# FINAL CODE COMPLIANCE CERTIFICATE

BUILDING CONSENT No. 10003981

249 MADRAS STREET, CITY, CHRISTCHURCH 8001

Alterations and additions to building

# GROWS SECTION XX SCALE 1:50 (MPROX)

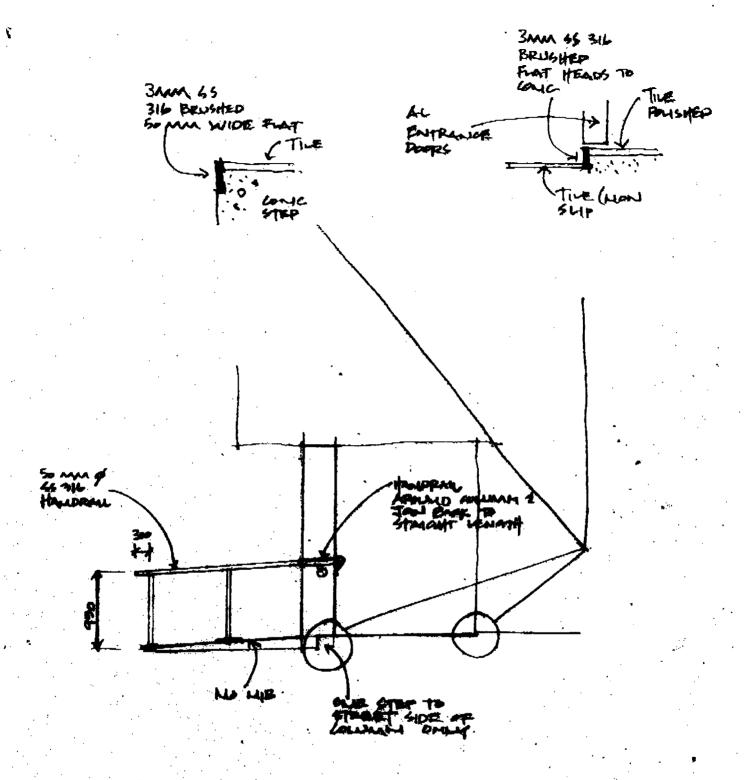
AMENDED PLANS
